Gulfstream G280

SERVICE BULLETIN

NUMBER 280-57-099

WINGS (ATA 57) – ADDING A DOUBLER TO
THE FORWARD SPAR AND RIB 0
ATTACHMENT

Location for Adding a Doubler Where Rib 0 is Attached to the Front Spar
Figure 6

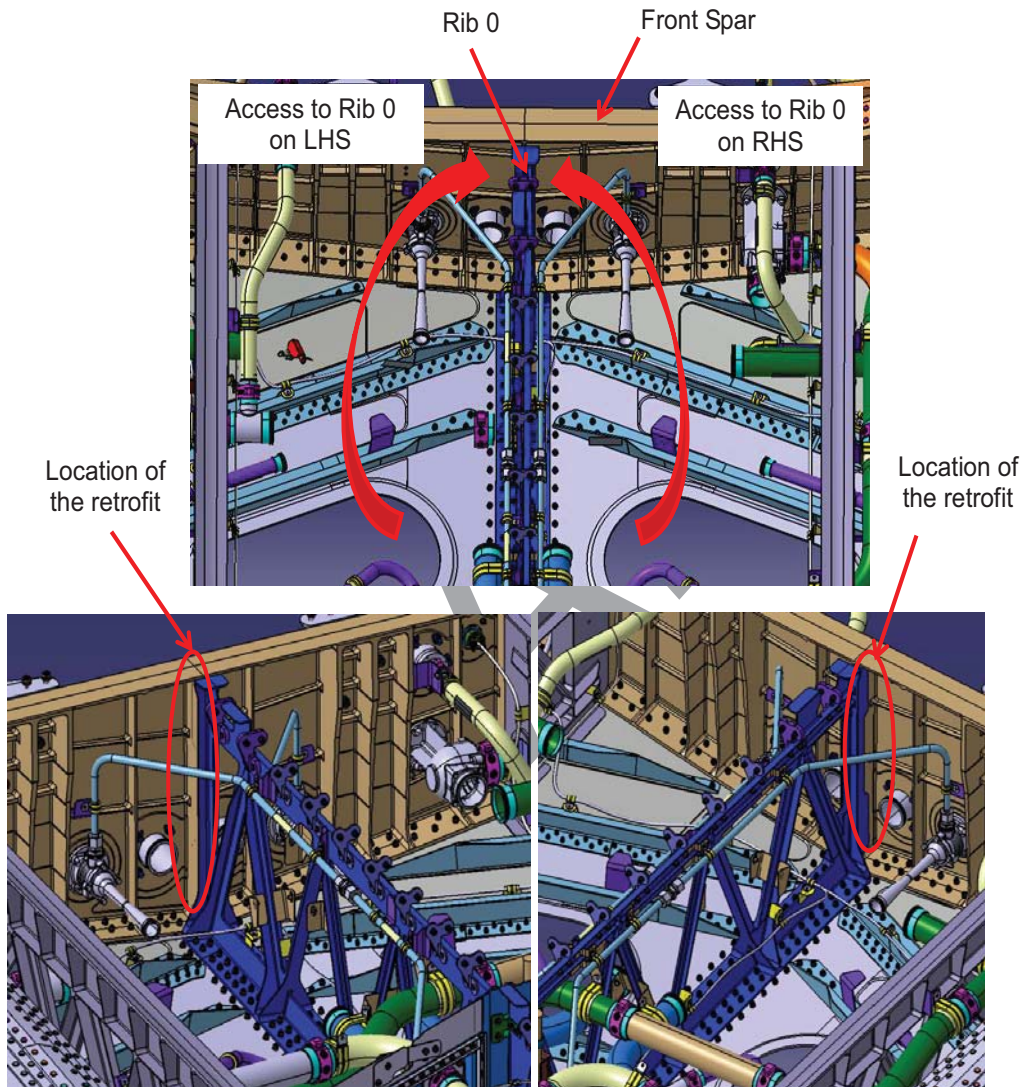
During full scale fatigue testing, a crack was found in the area of the attachment of wing Rib 0 to the front spar and it was determined that a doubler is needed to be added at that location.

This service bulletin provides instructions to install a doubler at the attachment location of the wing Rib 0 and the front spar.

19. Locate the doubler, P/N 30P171632200-001 flat on the spar vertical stiffener and spar web as shown in Figure 9 and clamp the doubler in place. Make sure the doubler is centered between the horizontal stiffeners on the forward spar and verify there is a minimum of 0.030 inch clearance around the doubler and the spar fillet radii.

Existing Fasteners to be Removed (and shop aid bullet location) at Rib 0 & Front Spar Joint
Figure 7

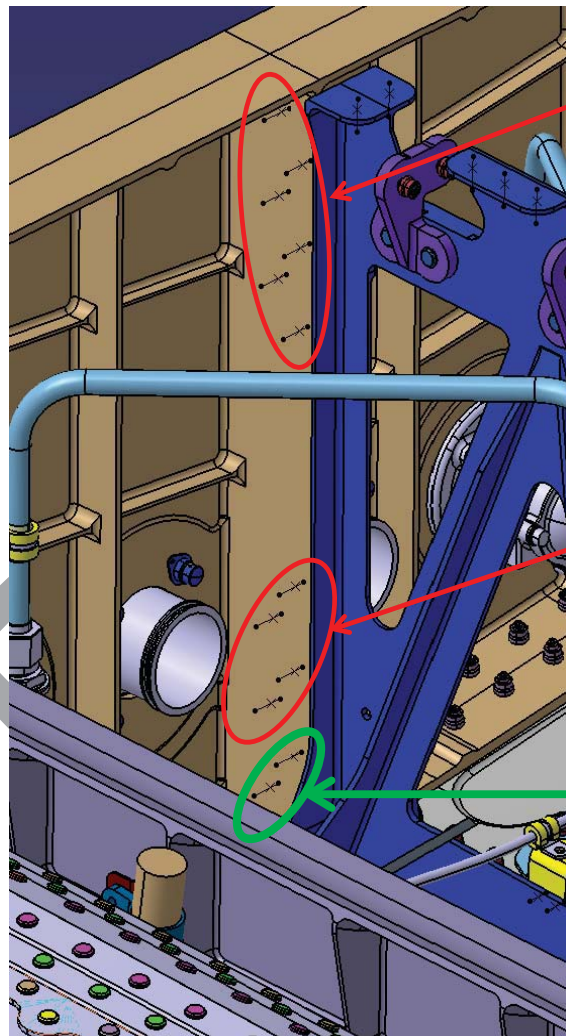
Remove two Collars and Hi-Lite pins in this area for the install of shop aid bullets. Remove the remaining Collars & Hi-Lite pins at the remaining locations

Remove the existing Collars & Hi-Lite pins at these 4 locations

CAUTION:
DO NOT
REMOVE THESE
TWO HI-LITES
OR THE
COLLARS

9. Remove 2 existing hi-lites and collars to allow for installation of 0.245-inch shop aid bullets. Refer to Figure 7.
10. Remove paint around the fastener holes to allow for a better visual inspection and NDT.

13. Remove the remaining eight (8) existing hi-lites at the upper and lower locations. Refer to Figure 10.
14. Remove paint around the fastener holes to allow for a better visual inspection and NDT.

NDT Area to be Performed on Forward Spar Vertical Stiffener and Rib 0
Figure 8

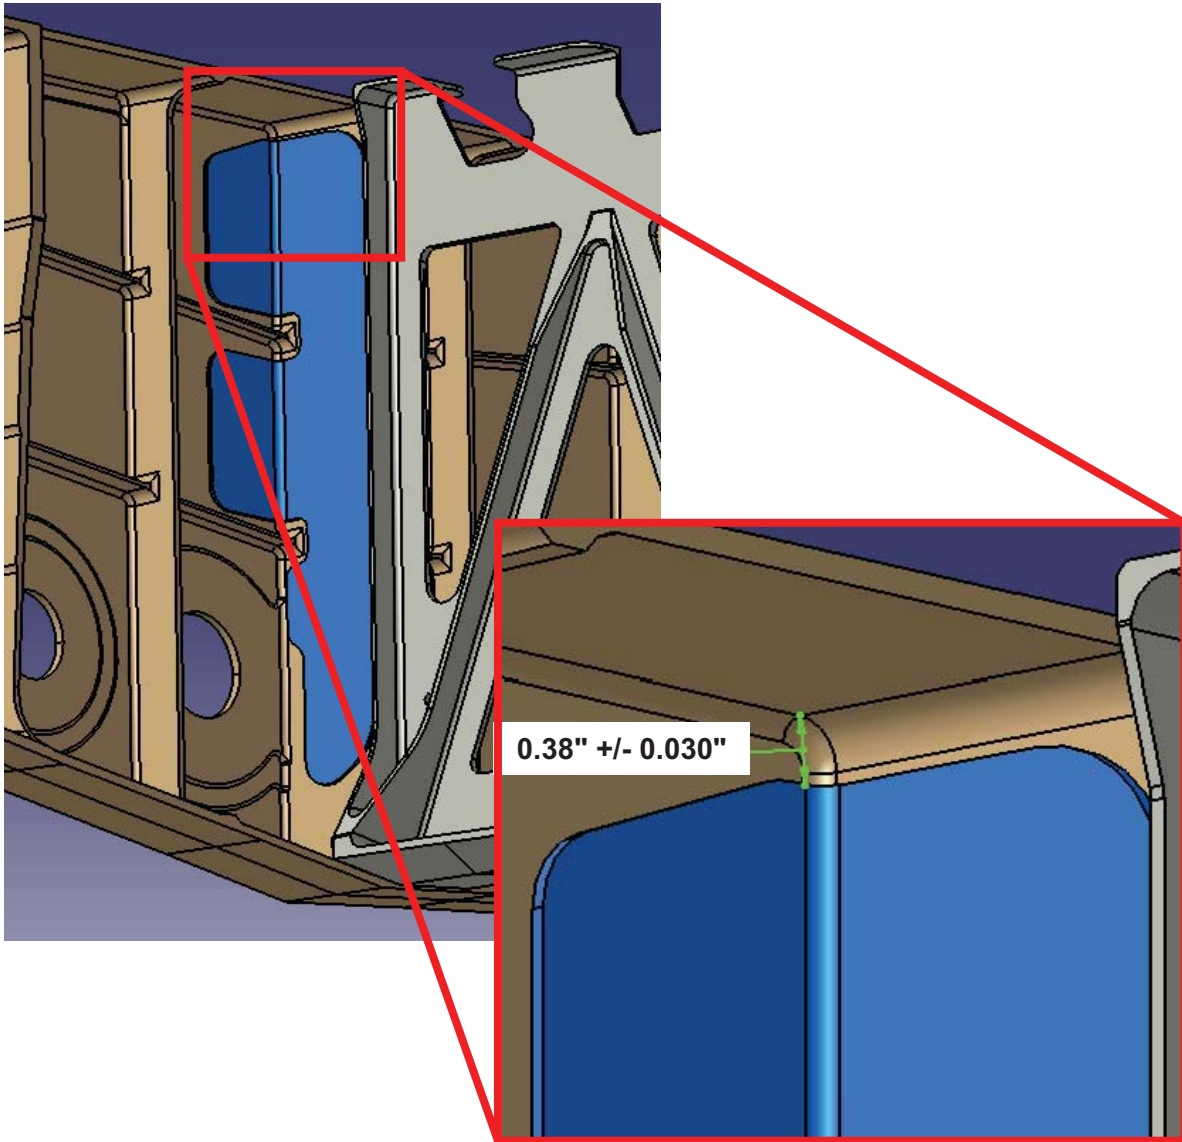
On Spar Stiffener side:

- HFEC & MFEC surface scan around & in-between all fastener holes (total of 12 fastener holes).
- Liquid (Dye) Penetrant NDT only in case cracking indication is found via one of the Eddy Current NDT methods.
- BHEC to the 10 fastener holes of which the fasteners were removed.

On Rib 0 side:

- HFEC surface scan around & in-between all fastener holes (total of 12 fastener holes).
- BHEC to the 10 fastener holes of which the fasteners were removed.

17. On the front spar vertical stiffener and Rib 0, perform the following NDT to inspect for cracks (refer to Figure 8):
 - High Frequency Eddy Current - HFEC (PS810300, PS810310)

- Mid Frequency Eddy Current - MFEC (PS810300, PS810310)
 - Bolt Hole Eddy Current (High Frequency) - BHEC (PS810300, PS810310)
 - Liquid (Dye) Penetrant (PS810100)

18. If any cracks are found, contact Gulfstream Customer Support.

Installation of Fasteners Attaching Doubler to Rib 0 in Oversized Holes
Figure 10

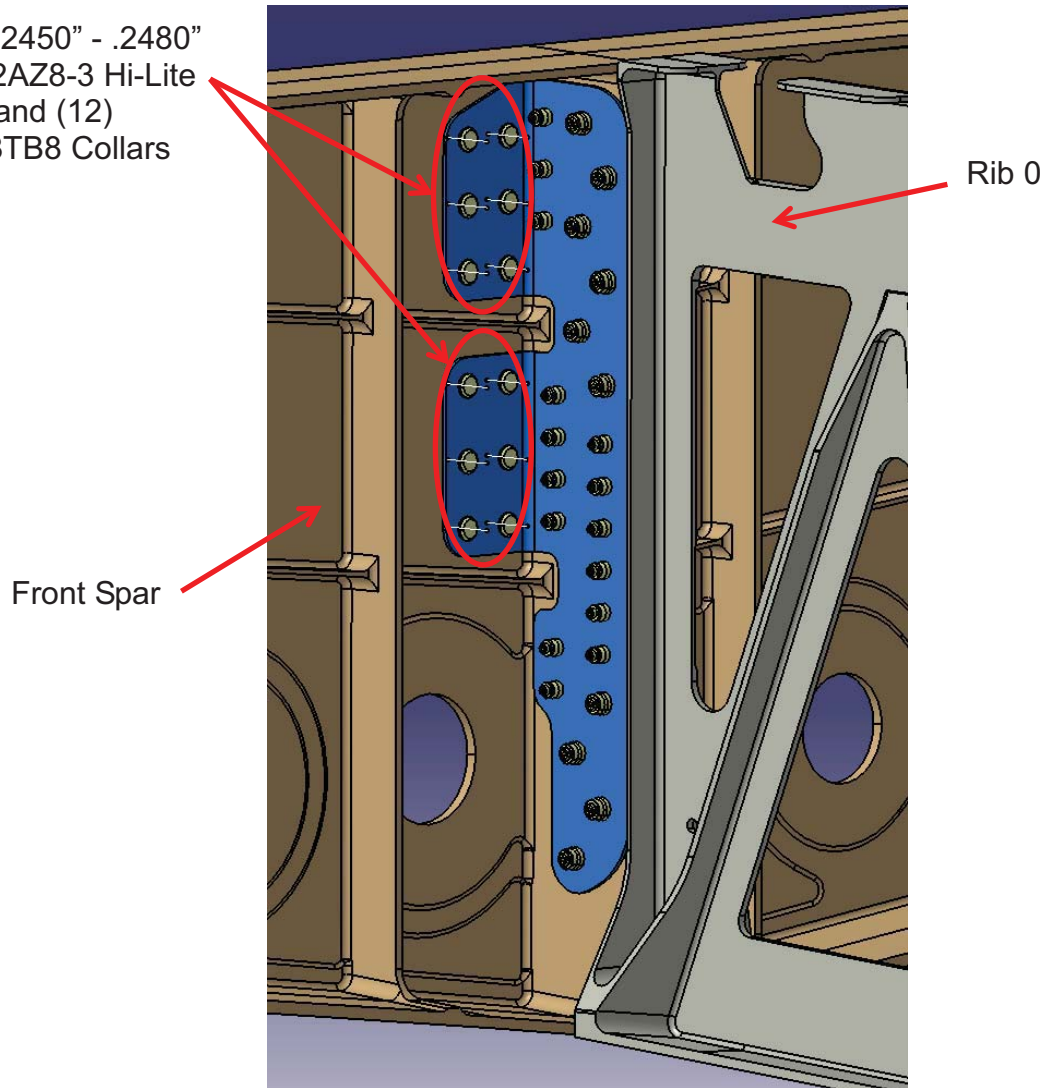
20. Using a drill block, back drill the doubler from Rib 0 and the spar vertical stiffener to match the existing hole size on Rib 0 and the spar vertical stiffener at eight (8) locations where existing fasteners were removed. refer to Figure 10.

21. Verify all holes for dimensional size and roundness before enlarging holes to 1st oversize.
22. Using a drill block, enlarge eight (8) holes on the doubler, the spar vertical stiffener and Rib 0 completely to 0.2606 - 0.2636 inch (1st oversize, interference fit) by drilling through doubler, spar vertical stiffener and Rib 0 at the locations shown in Figure 10. (see step 30 for fastener definition).

23. If 2nd oversize is required, enlarge the hole size diameter on the doubler, spar vertical stiffener and Rib 0 for these eight (8) holes completely to 0.2762 - 0.2792 inch (2nd oversize interference fit). Contact Gulfstream Customer Support for the fasteners.

30. Install eight (8) 1st oversize fasteners, P/N HST110AZ8-4 Hi-lite pins and eight (8) collars, P/N HST184GG-8 collars. Refer to Figure 10.
31. Remove the two (2) 0.258-inch shop aid bullets and repeat step 30 for the remaining two locations.
32. Install twelve (12) Hi-lite pins, P/N HST12AZ8-3 and twelve (12) collars, P/N HST1078TB8 wet with PR1776M in the holes attaching the doubler to the front spar we as shown in Figure 11.
33. Install nine (9) Hi-lite pins, P/N HST12AZ6-3 and nine (9) collars, P/N HST1078TB6 wet with PR1776M in the holes as shown in Figure 12.
34. Install six (6) Hi-lite pins, P/N HST12AZ6-4 and six (6) collars, P/N HST1078TB6 wet with PR1776M in the holes as shown in Figure 13.

Installation of Fasteners Attaching the Doubler to the Front Spar Web
Figure 11

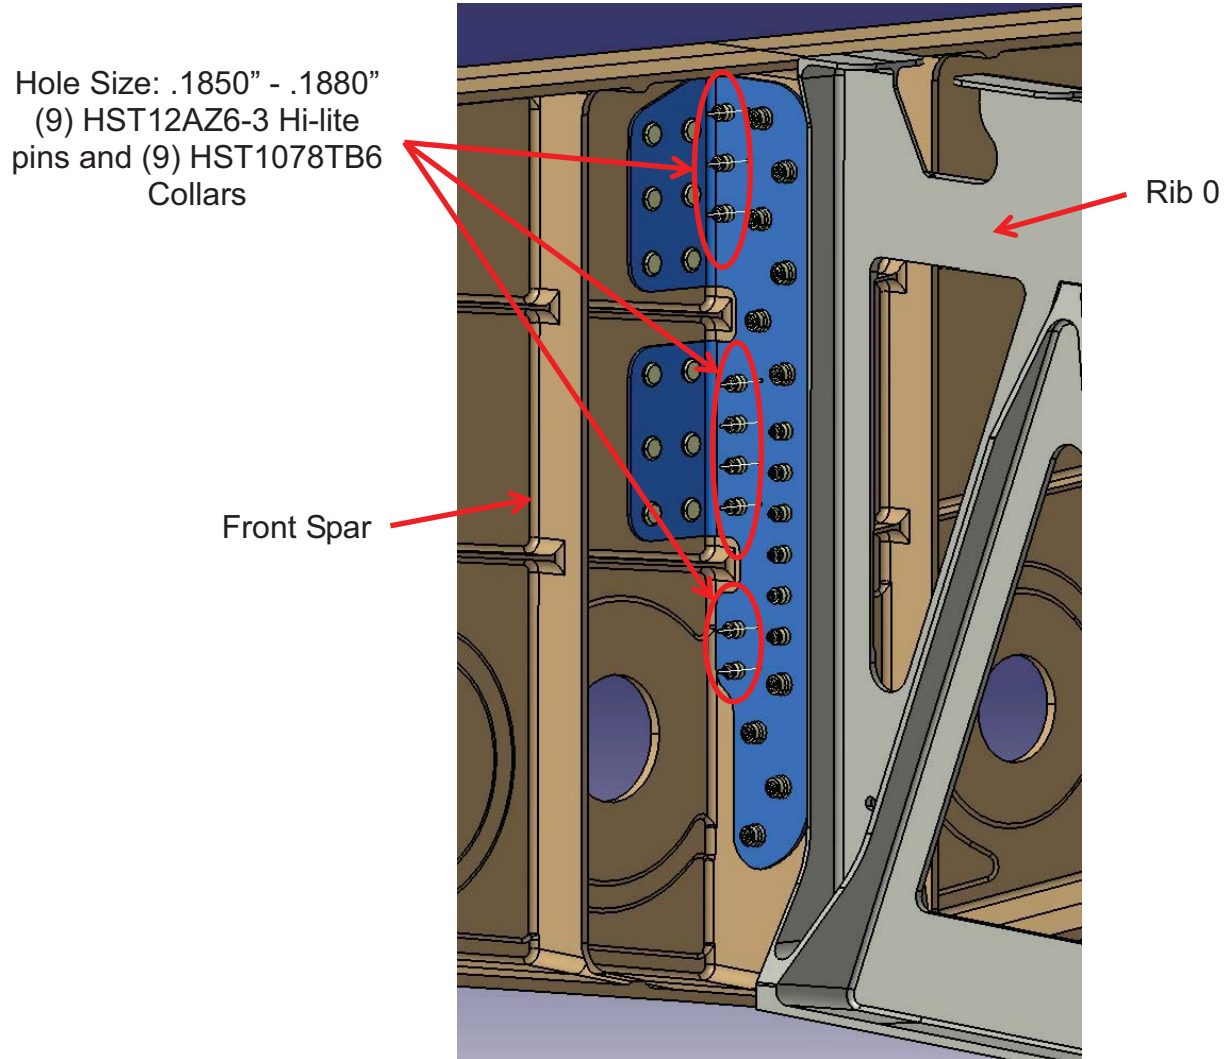
24. Using the pilot holes on the doubler, drill twelve (12) 0.2450 - 0.2480 inch holes (interference fit) from the doubler through the spar web at the locations shown in Figure 11 (see step 32 for fastener definition). Maintain 0.500 inch minimum edge margin on the doubler.

Hole Size: .2450" - .2480"
(12) HST12AZ8-3 Hi-Lite
pins and (12)
HST1078TB8 Collars

Installation of HST12AZ6-3 Hi-Lites Attaching the Doubler to Rib 0
Figure 12

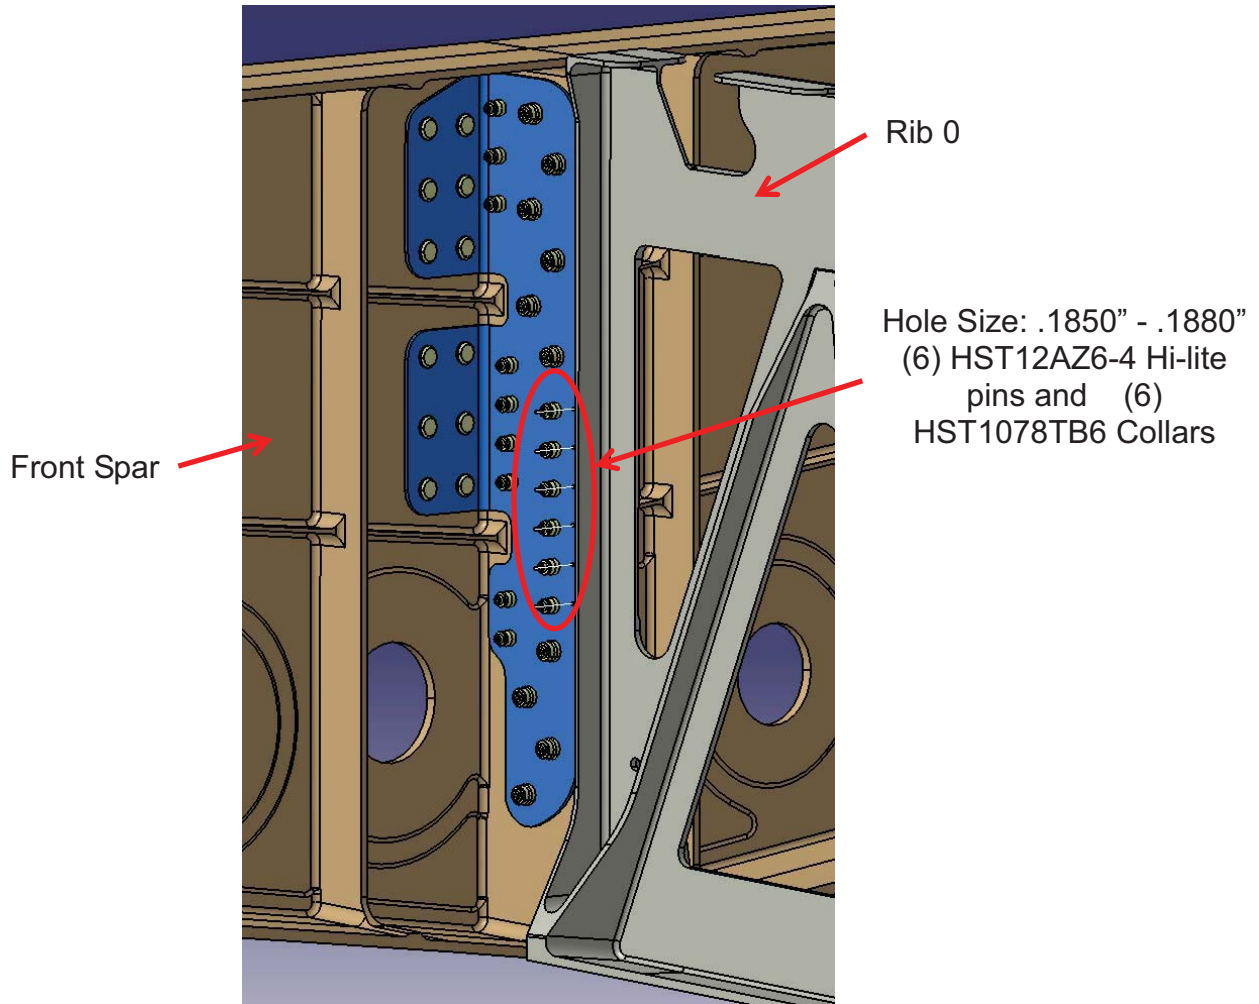
25. Using the pilot holes and drill block on the doubler, drill fifteen (15) 0.1580 - 0.1880 inch holes (interference fit) from the doubler through the spar vertical stiffener and Rib 0 at the locations shown in Figures 12 and 13 (see steps 33 and 34 for fastener definition). Maintain 0.375 minimum edge margin on all parts.
